NAVIGATION AND VESSEL INSPECTION CIRCULAR NO. 4-85 CHANGE 1

**Subj: Change 1 to NVIC 4-85 of 29 May 1985, Subj: Recalls and Other
Corrective Measures for Lifesaving and Fire Protection Equipment**

FITZ-WRIGHT SUITS RECALL PROCESS

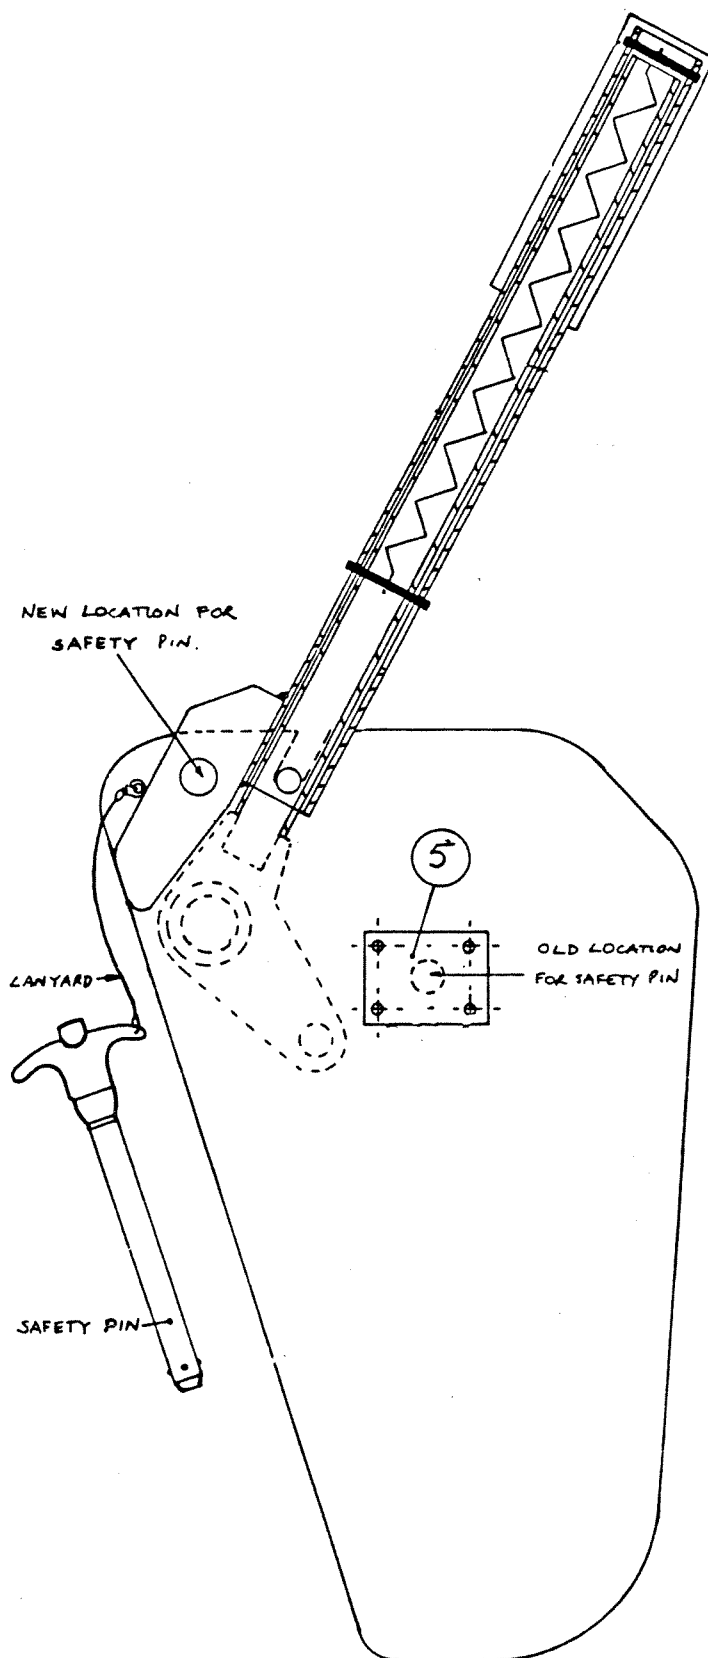
- a. Fitz-Wright exposure suits up to and including Lot 116 were inspected and tested for Coast Guard approval by Warnock Hersey Professional Services but were not marked with an approval number on the suit.
- b. Production inspection has since been taken over by Underwriters Laboratories (UL), but suits from lot numbers 117-132, 134, and 136-137 may have been labeled as Coast Guard approved even though they were not inspected and tested at the factory by Warnock Hersey or UL.
- c. Some Fitz-Wright suits have been found to have no lot numbers, and their factory inspection status can not be determined.

- a. Where records in the custody of Underwriters Laboratories indicate that a lot numbered 116 or lower was inspected by Warnock Hersey Professional Services, the suits may be relabeled in the presence of a UL inspector.
- b. Where the records indicate that any lot was not inspected by an independent laboratory, representative samples of the lot must be returned to Fitz-Wright for testing by a UL inspector. Fitz-Wright will provide replacements for the samples recalled for testing. After samples of a lot have been tested and inspected, the lot will be approved and all suits of that lot may be relabeled in the presence of a UL inspector.
- c. Any suit which does not bear a lot number can not be considered Coast Guard approved.

- c. The flow chart on the following page is provided to guide decisions on testing and relabeling.

- a. Coast Guard inspectors should contact Commandant (G-MVI-3) when suspect suits are encountered, giving lot number of suits, approval number if marked, and identity of vessel and operator. Vessel need not be detained. Commandant (G-MVI-3) can be reached on FTS 426-1444.

- b. Operators may contact Underwriters Laboratories to determine the status of suspect suits and arrange for relabeling. If samples from the lot are needed, the operator will be referred to Fitz-Wright to arrange for replacements and shipping of samples. Point of Contact at UL is:

Note: If there are no lot numbers on the suits they must be recalled for individual testing.

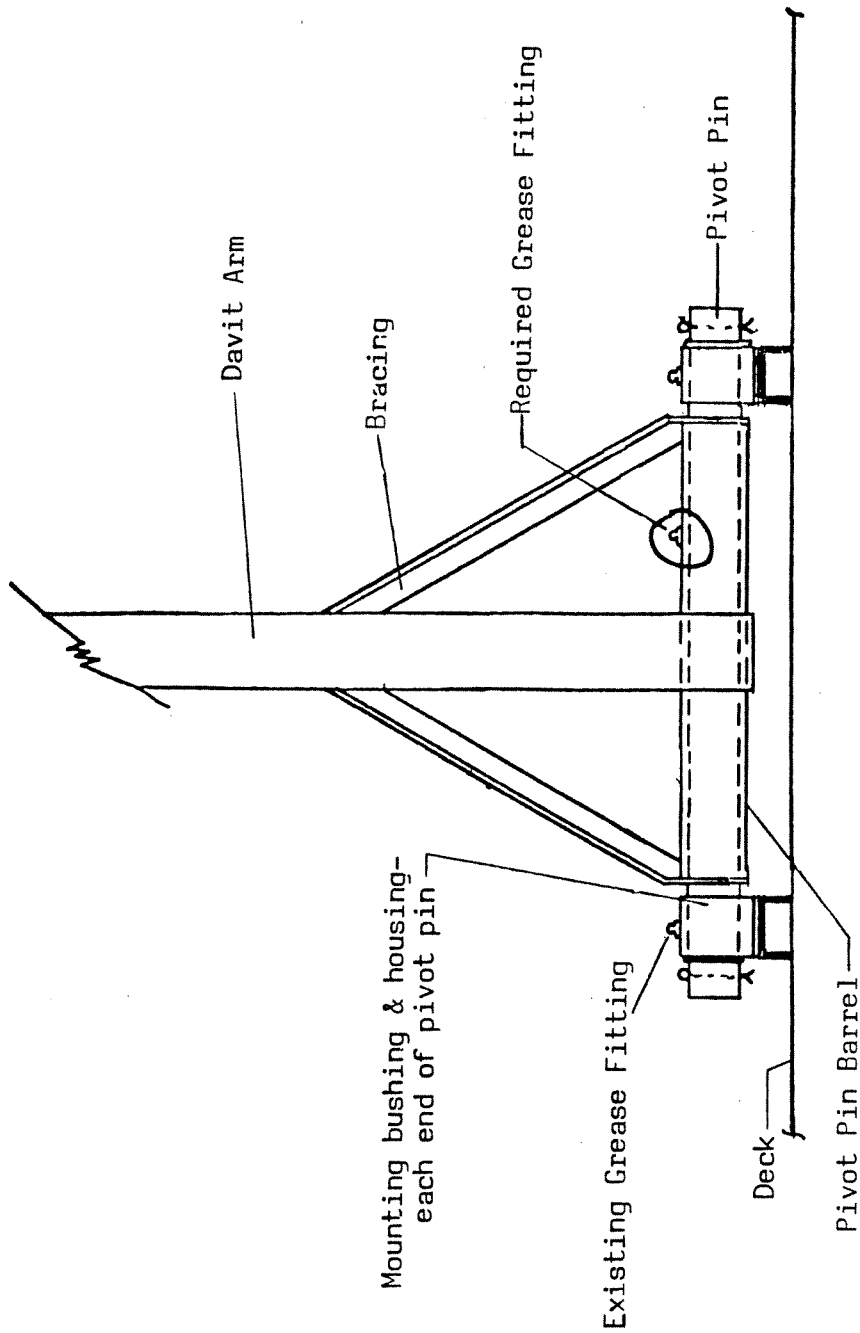
1. PROBLEM. The safety pin on the Titan release gear operating handle used in certain Watercraft America lifeboats, can be inserted before the handle is in the safe, fully closed position. In this condition, the release hooks may appear to be fully closed, but may unexpectedly open when a load is applied.

- a. Titan release gear with approval number 160.033/69/0 must be modified. Titan gear that has been modified can be identified by the cover plate over the old safety pin hole (item 5 on the drawing on the following page), and by the plate added to the release gear handle to accommodate the new safety pin location (see "NEW LOCATION FOR SAFETY PIN" on the drawing).

3. ACTION.
 - a. Vessel and MODU operators having Watercraft America lifeboats equipped with Titan gear having approval number 160.033/69/0 shall make sure the release gear is modified in accordance with Watercraft America drawing SP-201 and Engineering Instruction P-131, both dated 28 October 1985. The Coast Guard Officer in Charge of Marine Inspection shall be notified before the modification work begins. The drawing and instruction may be obtained from:

**ILLUSTRATION 1**

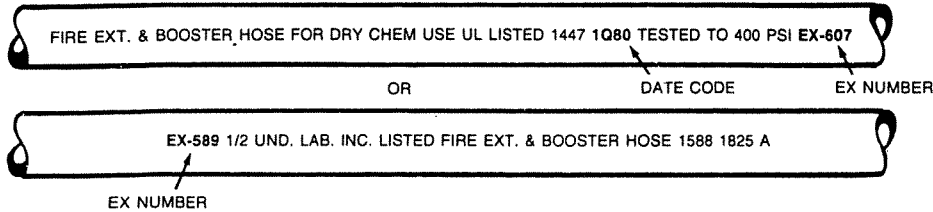
1. If extinguisher has a yellow "Inspected" sticker on the front, go to step 9.
2. Find U.L. Listing information printed on hose (either white print or molded on hose cover). (See illustration 1 below.)

3. If there is no printing, or printing is unreadable, replace hose assembly and destroy old hose.
4. Refer to **EX** number on hose, if it is **NOT** EX-607 or EX-589, hose is good, do **NOT** replace.
5. If EX-607

6. If EX-607, refer to date code (Example 1Q80 means 1st Quarter 1980)
7. If Date Code is between 1Q77 and 4Q83, replace hose assembly, destroy old hose. If dated **BEFORE** 1Q77, hose is good, go to step 9.

**ILLUSTRATION 3**

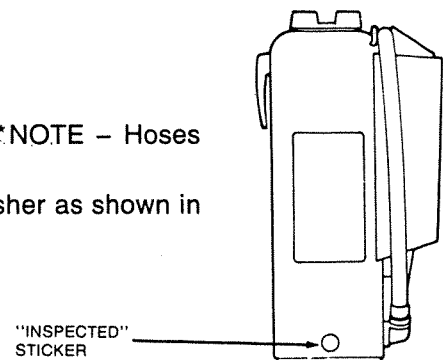
9. Perform recommended inspection and maintenance on **ALL** extinguishers. *NOTE - Hoses not included in this program may need replacement due to normal wear.
10. When all work is completed, place yellow "Inspected" sticker on extinguisher as shown in illustration 3.
